Re: Bus Connects Templeogue/Rathfarnham to City Centre Core Bus Corridor Scheme
Templeogue/Rathfarnham to City Centre

Submission on the proposed
construction of the Templeogue /
Rathfarnham to City Centre Core Bus
Corridor

**TEMPLEOGUE/RATHFARNHAM TO CITY CENTRE - CORE BUS CORRIDOR SCHEME
REVIEW ON BEHALF OF #55, #59, #61, #63, #65, #67 & #71 RATHFARNHAM ROAD:
AN BORD PLEANÁLA REFERENCE ABP-316272-23**

TEMPLEOGUE/RATHFARNHAM TO CITY CENTRE - CORE BUS CORRIDOR SCHEME
REVIEW ON BEHALF OF #55, #59, #61, #63, #65, #67 & #71 RATHFARNHAM ROAD:
BASED ON AVAILABLE DESIGN DETAILS AND TOPOGRAPHICAL SURVEY

Figure 1 – Details assumed for the Purposes of this Study

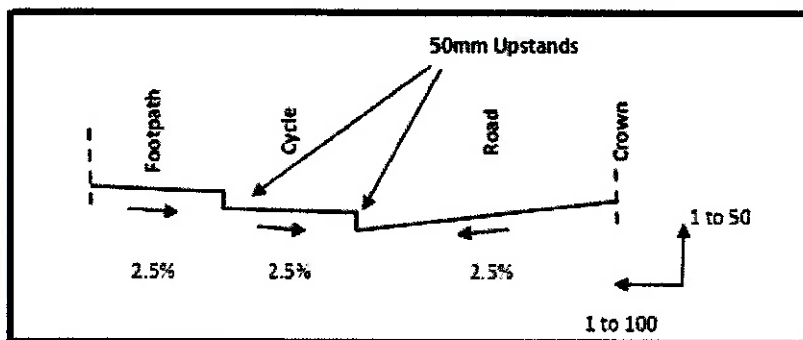
In terms of the impact upon individual residences along the route, given the scant information provided within the statutory documents and the planning application we have had to assume some typical design details (gradients and details which would normally apply to schemes of this nature, with the assumed gradients as illustrated below as *Figure 1*).

Figure 2 – Profile for #55 Rathfarnham Road

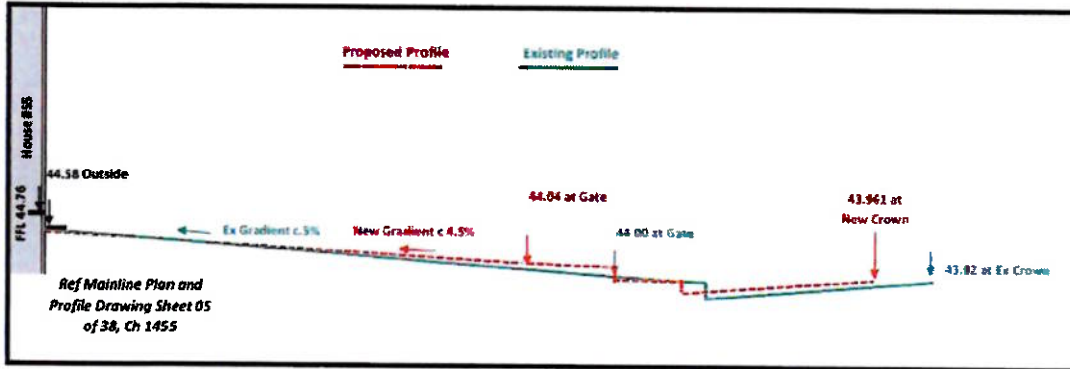
House Details	Current Total Gradient ¹	Future Total Gradient ²	Comment
55 Rathfarnham Rd	5%	4.5%	Improvement
59 Rathfarnham Rd	7.6%	9.6%	Significantly Steeper
61 Rathfarnham Rd	7.6%	8.9%	Significantly Steeper
63 Rathfarnham Rd	6.3%	10.5%	Significantly Steeper
65 Rathfarnham Rd	9.6%	11.1%	Significantly Steeper
67 Rathfarnham Rd	10.6%	13.6%	Significantly Steeper
71 Rathfarnham Rd	8.2%	9.3%	Steeper

Figure 3 – Profile for #59 Rathfarnham Road

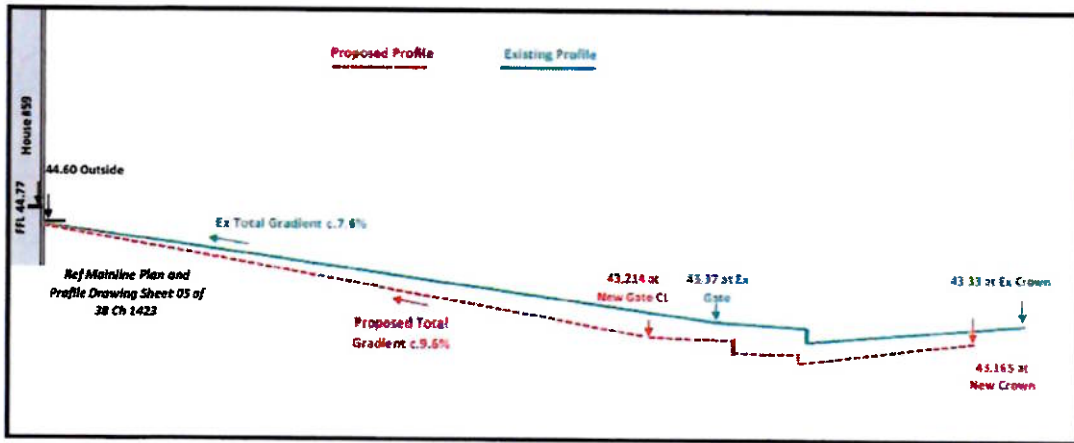
We conclude that the Bus Connect plans (as per the Planning Application, based on the design data provided) appear to result in a significantly steeper approach to the majority of the subject dwellings, clearly contravening National Building Control Regulations.
